**The Old House, 16 Station Road,
Littlethorpe, Leicestershire:
Historic Building Impact Assessment**

For: J & N Builders Ltd

DCI Architecture Ltd

ULAS Report Number 2008-034

Drawing:
Planning Drawing 1 of 2

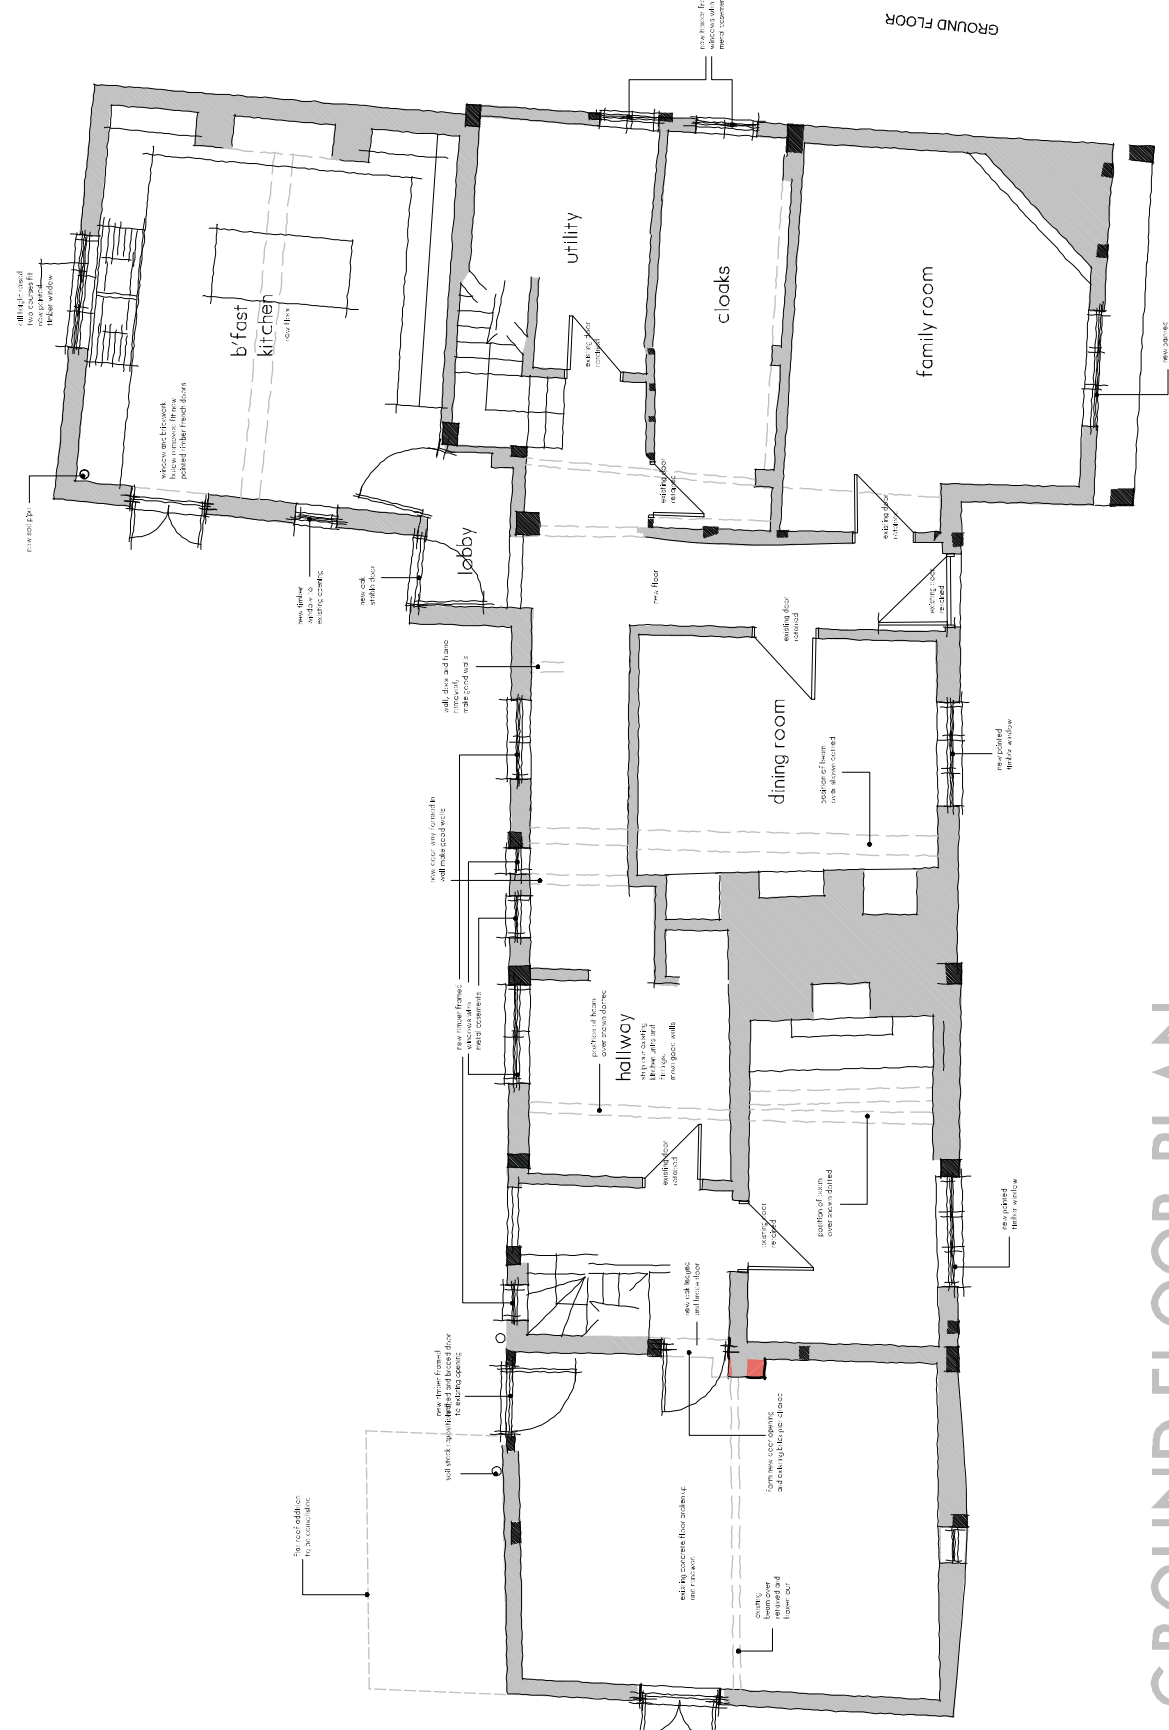
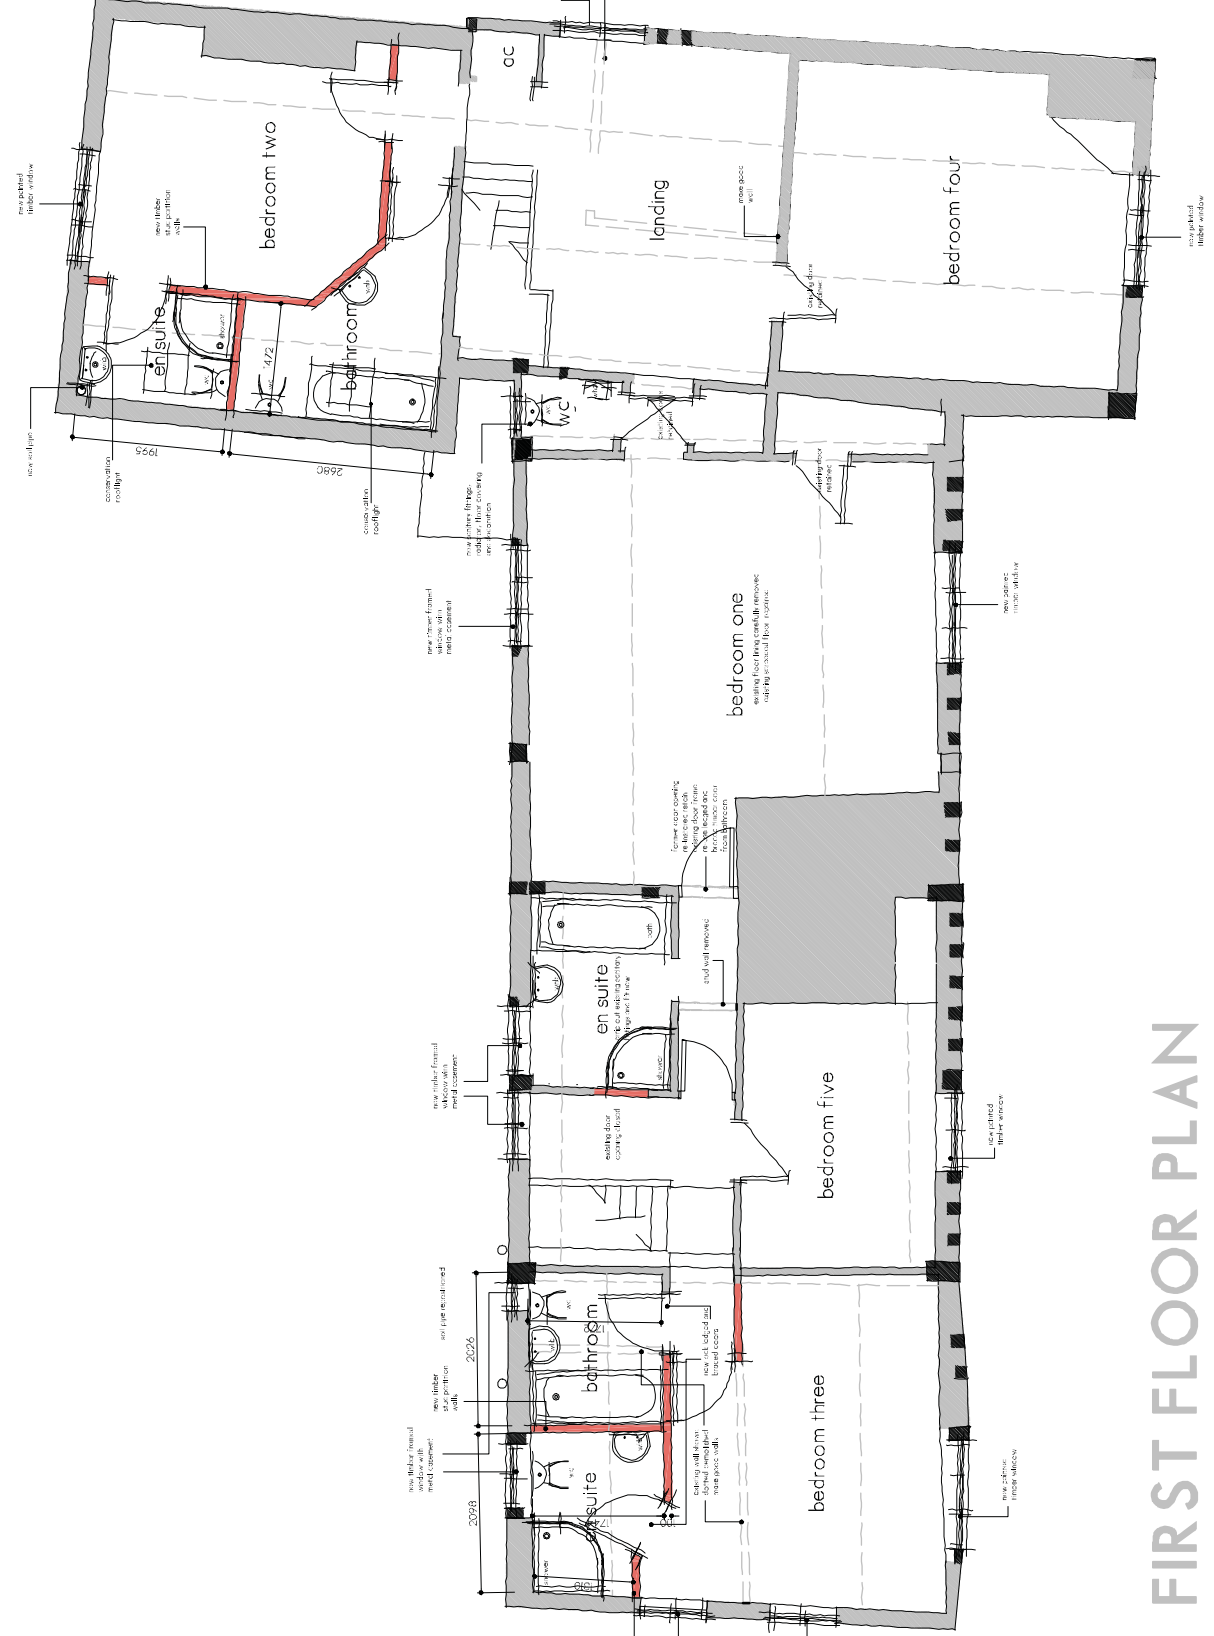
The initial Impact Assessment was based on proposed development plans supplied by the architect. Revised submission proposals (drawing nos. 477.JN-46) include some variations to the earlier scheme. These are covered in the relevant section under a **Supplement** heading.

- No significant changes proposed. The floor has been broken out and all fittings removed.
- **Supplement.** Remove window in north wall and extend opening down to floor, install painted timber French doors: limited impact. The window proposed for removal is of 20th century date and its design is not particularly sympathetic to this element of the building. The removal of brickwork below the existing opening will not have any significant detrimental effect. See also general comment on replacement of windows in section 5.3 below.

- **Supplement:** The revised scheme proposes a single ground floor opening in the north wall accommodating a pair of French doors. The impact on built fabric is not considered to be significant. The visual effect of the paired windows initially proposed, balancing those on the first floor, was more appealing than a single, off-centre opening. The existing glass brick window in the front elevation will be replaced with a new painted timber window in the existing opening, see comment above.

- **Supplement:** the revised drawings propose the complete removal of the inserted partition walls forming bathroom F3, returning the landing area to its earlier proportions. The bathroom would be relocated within room F4 (see below). This arrangement overcomes the issues of providing natural light and ventilation to the bathroom and the routing of services within this 'sensitive' part of the building. It also creates a less restricted, well-lit first floor landing. Removing the bathroom from this area also has the longer term benefit of avoiding incremental damage from the inevitable periodic replacement of sanitary accommodation. Similarly any long term effects of prolonged exposure to a damp atmosphere on early timberwork, infill and thatch will be avoided. Removing the early stud walls will remove evidence of an episode in the history of the building; however this could be adequately mitigated by providing a record of this area in its present state prior to alteration.

- **Supplement:** The revised plans relocate the bathroom from the landing (see F2 & F3 above) to that part of Bedroom 2 previously proposed as a dressing area, adjacent to the en suite. Although this does alter the layout of the room, it has the significant advantage of allowing the plumbing and waste for the two bathrooms to be combined/rationalised and removes these services from the historically more sensitive area of F2. Natural light and ventilation to the bathroom and en suite are provided by conservation roof lights on the north slope of the slate-covered roof; the fabric impact of their installation is negligible.

- **Supplement:** it is proposed to replace all of the windows, within the existing openings (except for one of the Kitchen G4 windows which is converted into a French door - see 5.1 above). All
